**Proposal Title:
Duplin County Emergency Management
Duplin County Schools
Rose Hill-Magnolia Elementary School Backup Generator**

RE: RFP Questions - Duplin County Emergency Management/ Duplin County Schools
Rose Hill-Magnolia Elementary School Backup Generator
Kenansville Elementary School Backup Generator
Beulaville Elementary School Backup Generator
North Duplin Elementary School Backup Generator

Project No: ES21070
Date: March 2022
Drawing No: E 101

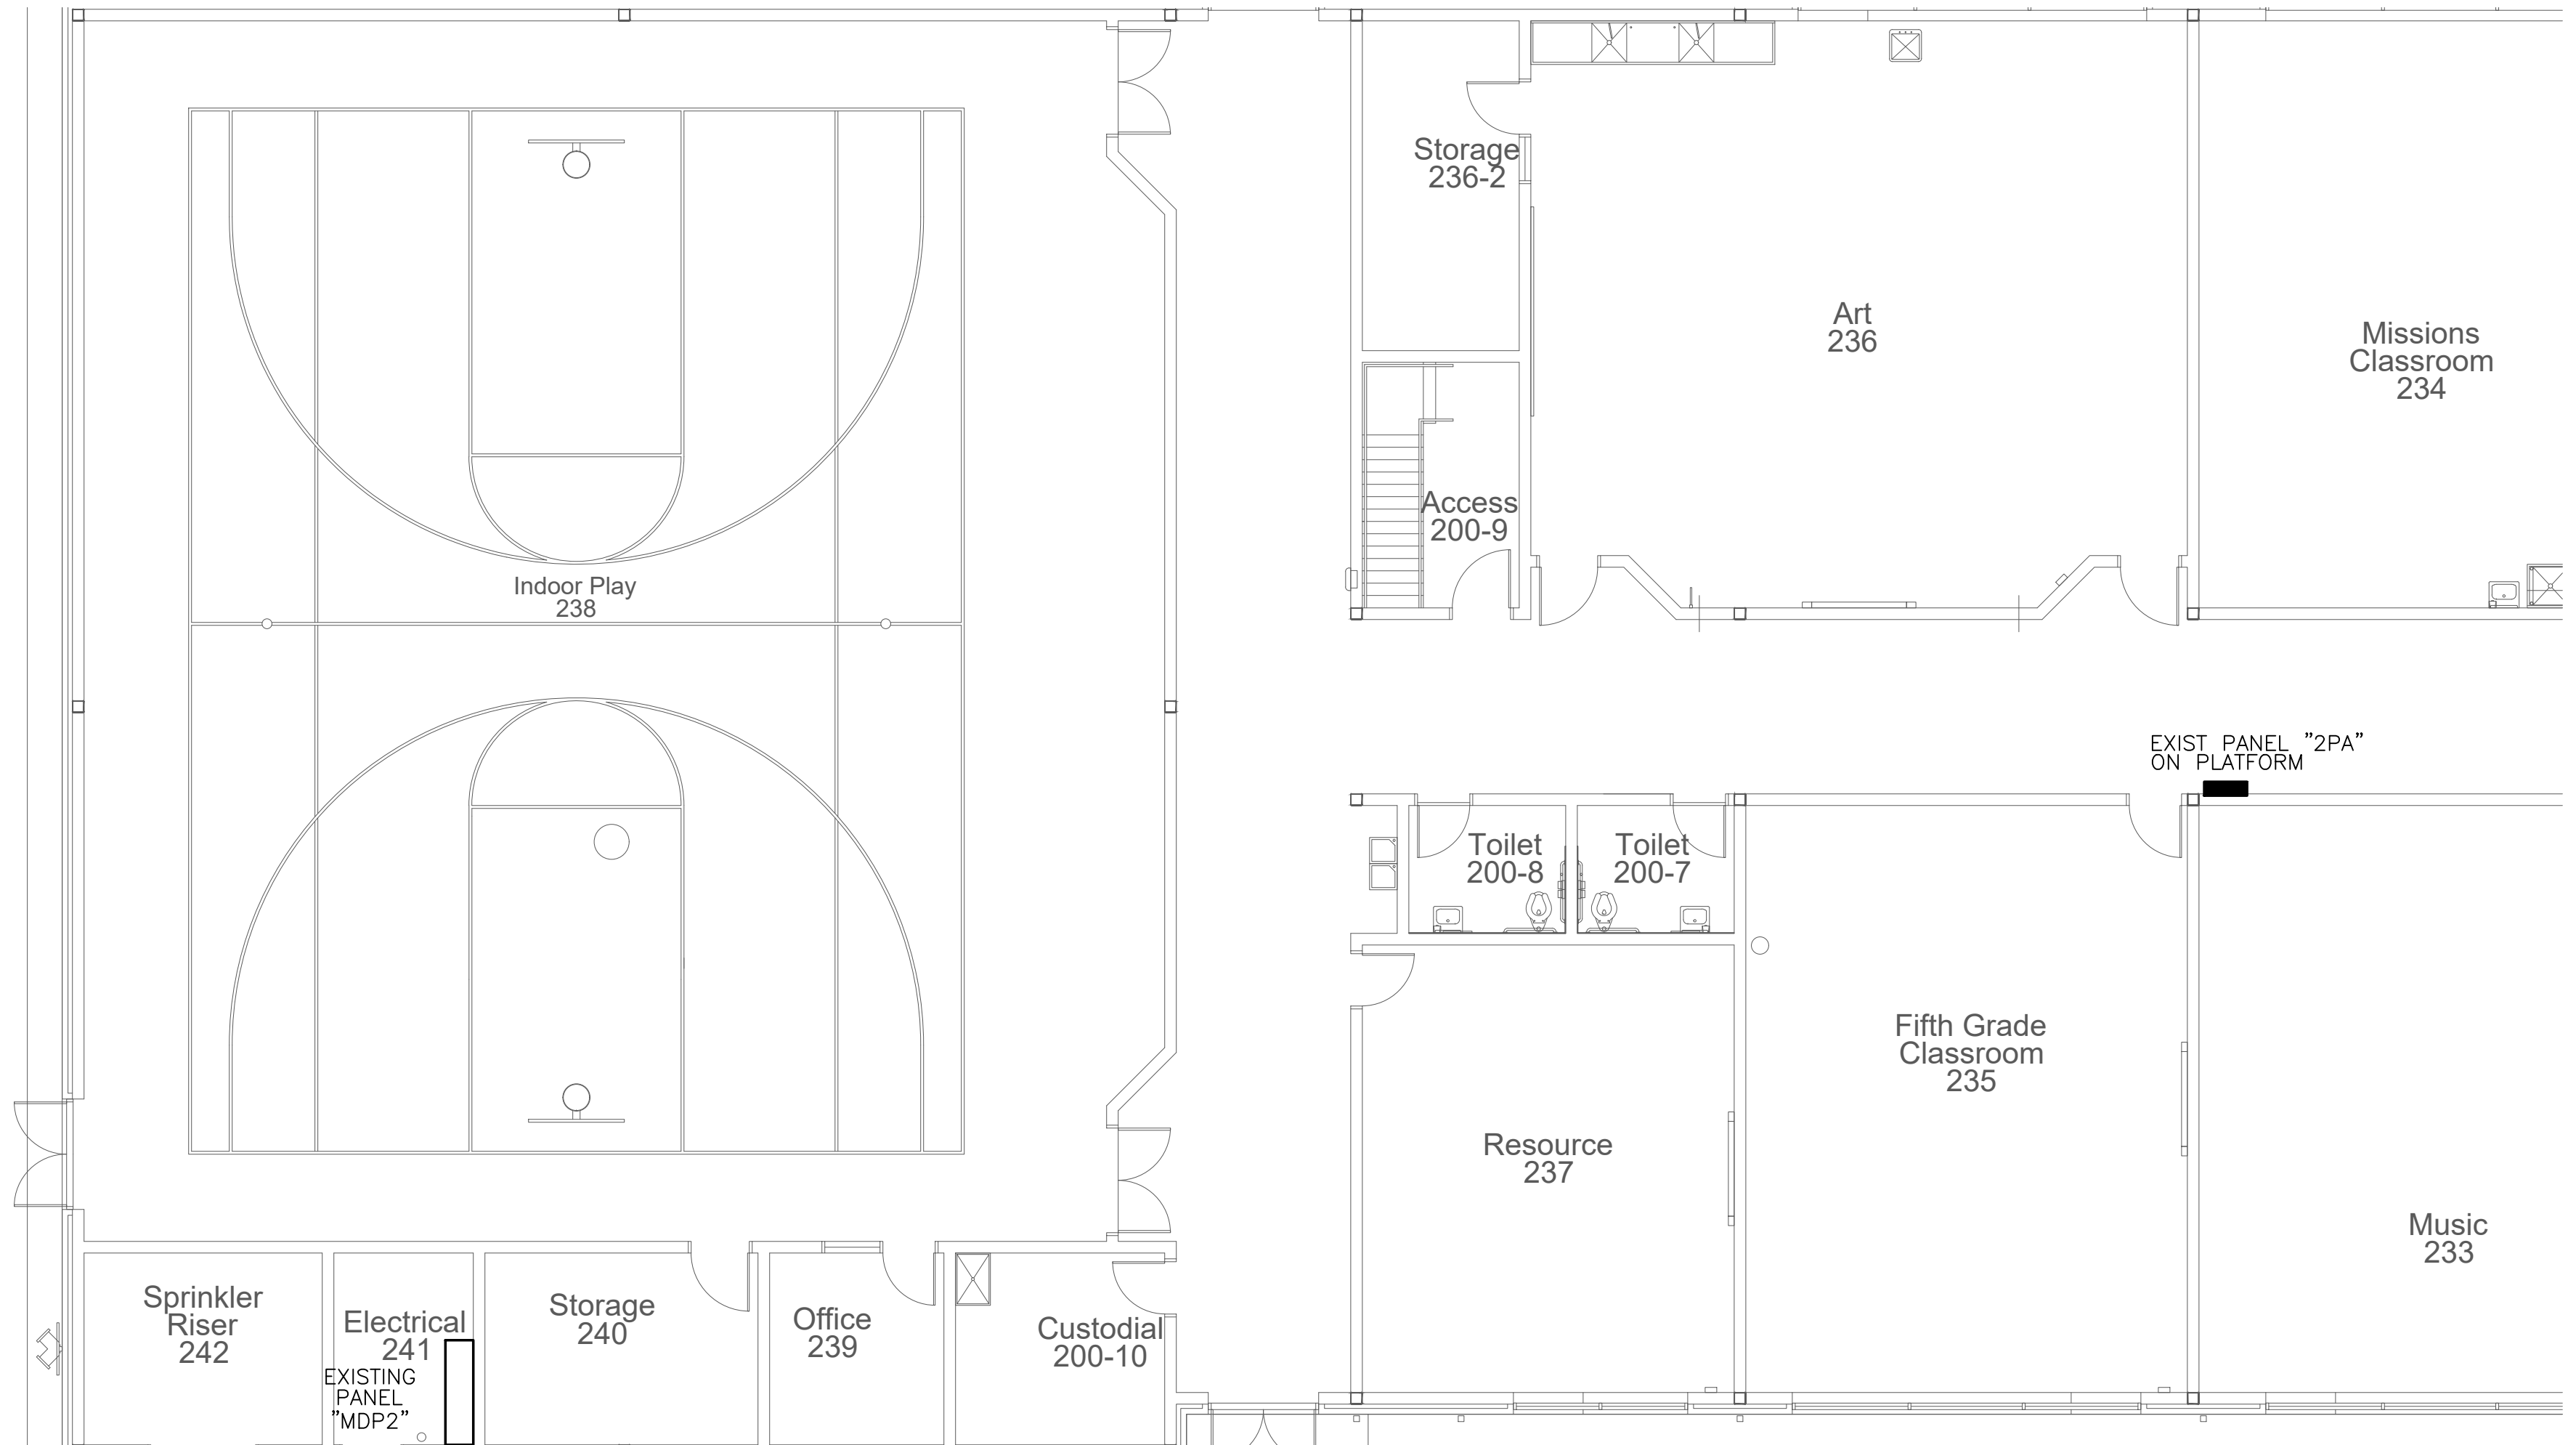
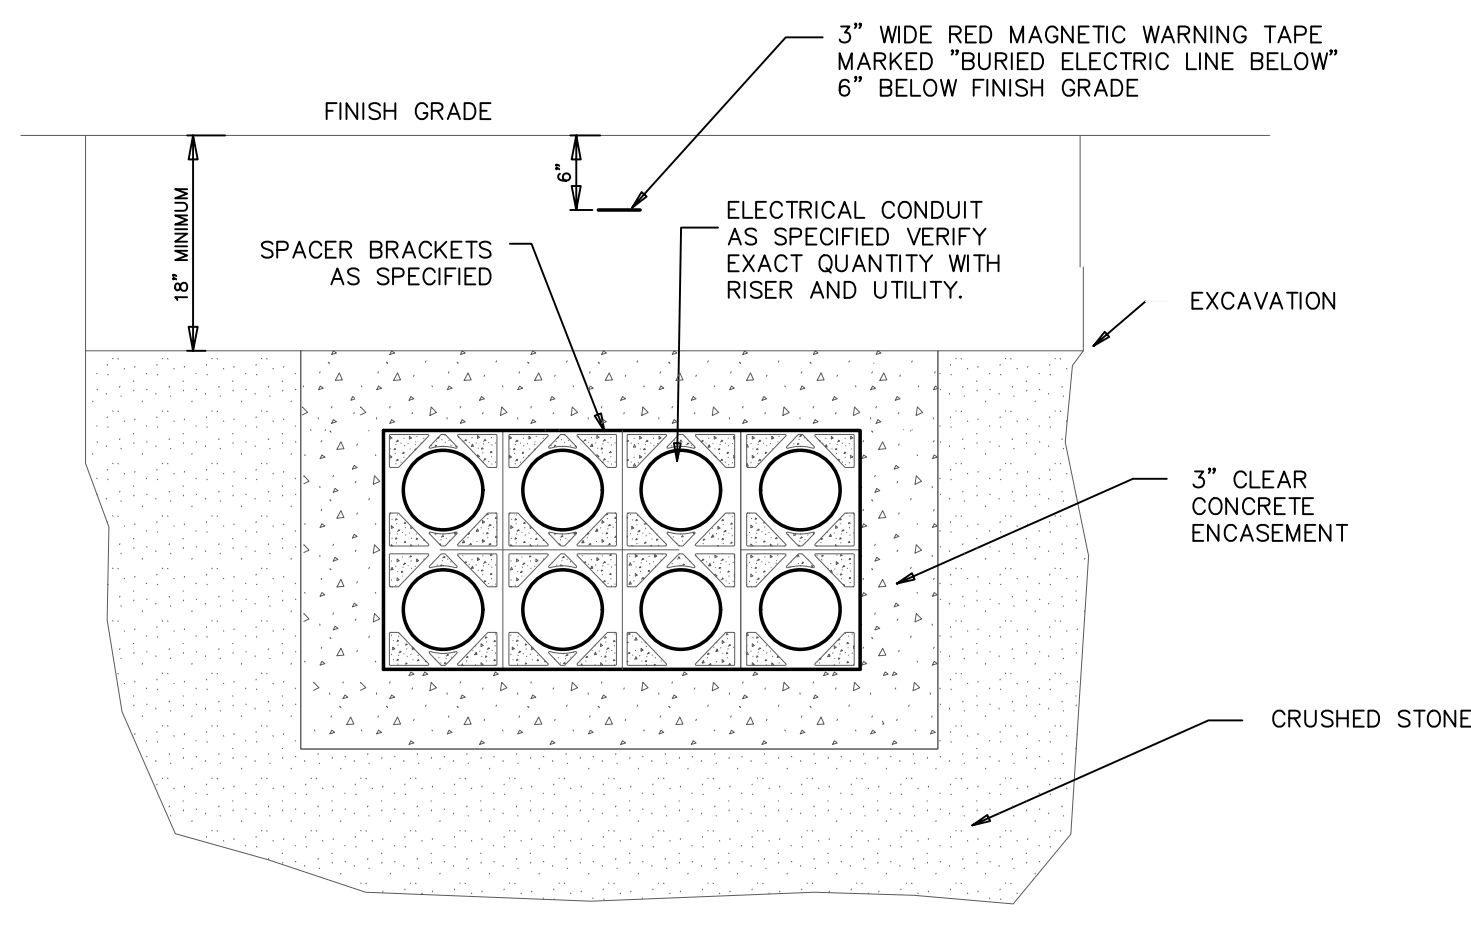
Q: Specs state the Enclosure Material shall be steel construction. Plans show Aluminum construction. Which is correct? Based on the location we recommend Steel. Also, the specs call for a weatherproof Enclosure only. Plans note Weatherproof and sound attenuated. Which is correct? We suggest Sound attenuation on the enclosure.

Q: Specs state a 48-hour base tank. Plans state 96-hour and 48-hour base tank. Which is correct?

A: *A steel housing with stainless steel hinges is allowable. A Level II sound attenuating housing is required.*

A: *A 48-hour base tank is correct.*
